**Subject: Safety-Kleen Systems, Inc. FLD 980 847 214, Operating Permit No. 0077130-HO-007
Clay County
First Notice of Deficiencies**

Your application for a hazardous waste permit has been reviewed and found to be incomplete. The required information and amendments necessary to complete your application are itemized in the enclosed Notice of Deficiencies.

Enclosure
Safety-Kleen Systems, Inc. FLD 980 847 214
Operating Permit No. 0077130-HO-007

Appendix A Site Photographs:

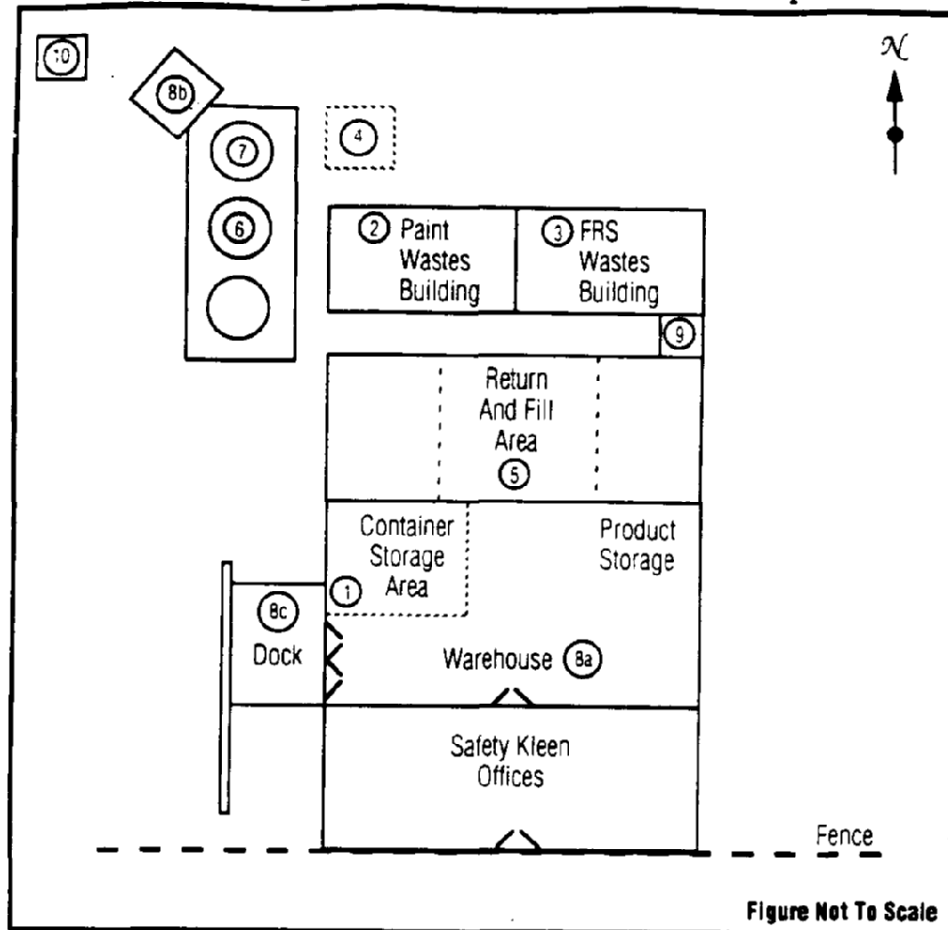
1. The first photograph should indicate it is the east side of the facility facing west.
2. The second photograph should indicate it is the west side of the facility facing east.
